SEWAGE DISPOSAL SYSTEM

MARYLAND STATE DEPARTMENT OF HEALTH

HOWARD COUNTY

ROAD 845 Day Road LOT _____

PROPOSED 12' x 18' ADDITION.

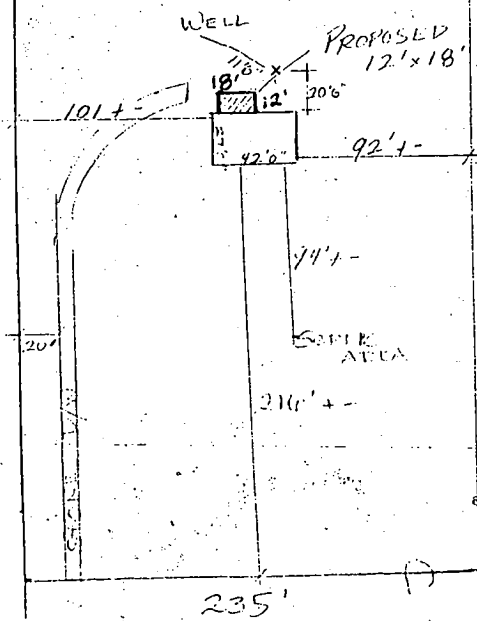
5/3/96 proposed addition should not impact septic system. Distance between well and proposed additions accepted by this office. (Concerns explained to builder before release of permit). *DAN K JOE*
